Difference for Migration: From KSZ8995MA/FQ to KSZ8895MQ/FMQ

AN3692

FIGURE 2: KSZ8895MQ/FMQ Pin Diagram.

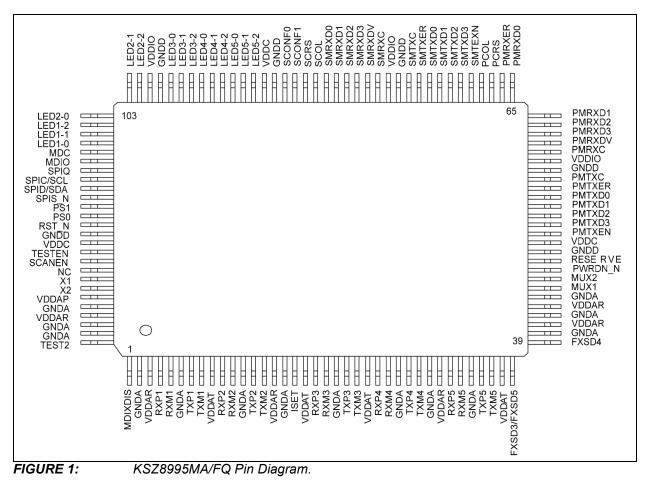
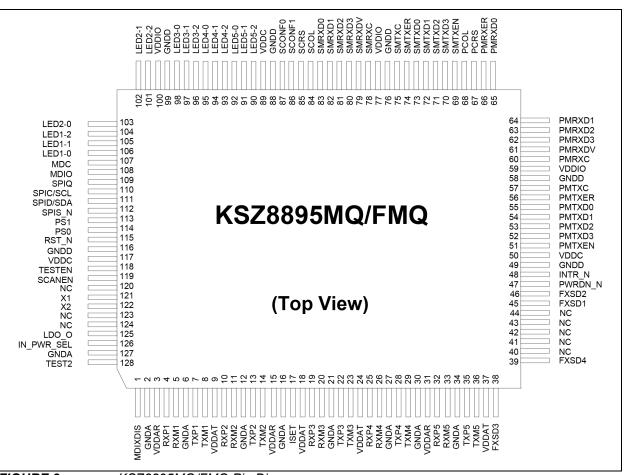
What follows is a description of the pin-to-pin compatibility if you are replacing KSZ8995 with KSZ8895 on an existing board:

- 1. Pin 1 to Pin 37 are the same between KSZ8995 and KSZ8895.
- 2. Pin 38 is NC (No Connection) in KS8895MQ/TMQ, pin 38 is FXSD3 in KSZ8895FMQ which is the same as KSZ8995FQ. Pin 39 is NC (No Connection) on the KSZ8895MQ/TMQ, pin 39 is FXSD4 on KSZ8895FMQ which is the same as KSZ8995FQ. Pin 38 and Pin 39 have internal pull-down for copper mode of the KSZ8895MQ/TMQ. Pin 38 and Pin 39 are signal detect pins for fiber mode of port 3 and port 4 on the KSZ8895FMQ.

- 3. Pins 40 through 46 are NC (No Connection) in the KSZ8895, which is different than in the KSZ8995. Therefore, when migrating from the KSZ8995 to the KSZ8895, pins 40 through 46 can either be left with their original KSZ8995 connections or be left unconnected. The MUX pins (pins 45 and 46) on the KSZ8995 are used for factory test and should be left unconnected for normal operation on KSZ8895MQ. For KSZ8895FMQ, pins 45 and 46 are FXSD.

- 4. Pin 47 PWRDN_N is the same as the hardware power-down pin between KSZ8995 and KSZ8895.
- 5. Pin 48 is NC on the KSZ8995, Pin 48 is INTR_N interrupt pin for the link change in the KSZ8895. It is okay to leave this pin floating if the interrupt pin is unused.

- 6. Pin 49 to Pin 122 are the same between the KSZ8995 and KSZ8895.
- 7. Pin 123 and Pin 124 are NC with internal no connection in KSZ8895. Pin 123 and Pin 124 are the power VDDAP and ground on the KSZ8995. So it doesn't matter when KSZ8895 is used instead of KSZ8995 with respect to these pins.

- 8. Pin 125 and Pin 126 are power and ground pins in the KSZ8995. Pin 125 and Pin 126 are LDO_O (1.2V LDO controller output) and IN_PWR_SEL (internal 1.2V LDO controller select) pins on the KSZ8895. When Pin 126 IN_PWR_SEL pin is ground '0', the internal 1.2V LDO controller is disabled and Pin 125 LDO_O is tri-stated. So the two pins will not be affected when the KSZ8895 is used instead of the KSZ8995 because Pin 126 is ground '0' with internal 1.2V LDO controller 125 is tri-stated with a power.

FIGURE 4: Connection Comparison for Fiber Module or Cap AC-Coupling with Two Copper Ports.

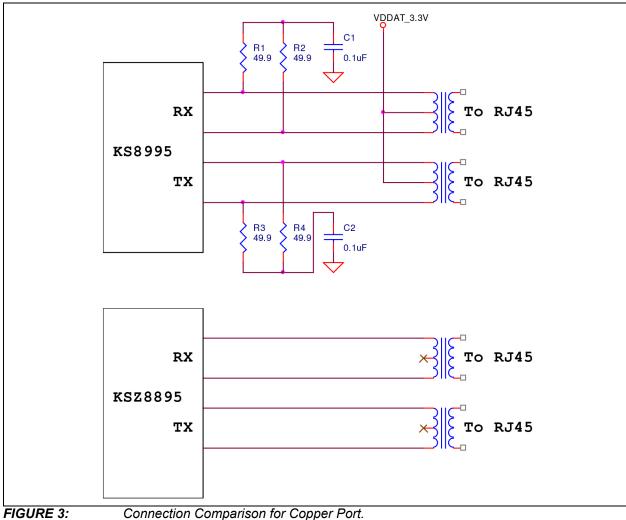
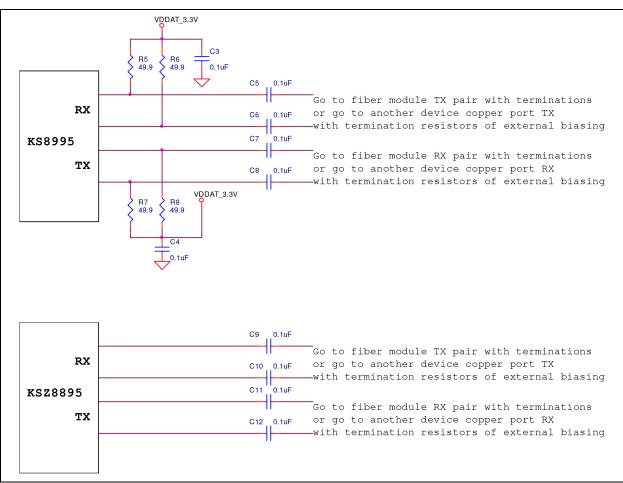
KSZ8895 supports on-chip termination and internal biasing, so all external 49.9Ω termination resistors on the RX pair and TX pair can be removed. There is no need to pull up to VDDAT for the center tap of the transformer, Just leave the center taps open or go through two capacitors to ground separately for the RX and TX paths. The transformer will not consume power and reduce the system power consumption. Please see the figures below.

If the old product with the KSZ8995 device being replaced by the KSZ8895 uses a quad transformer, the quad transformer should be changed to part number of the H1664NL, in which the internal center taps of the RX and TX is disconnected with no connection. Use Pulse H1664NL or other similar quad transformer.
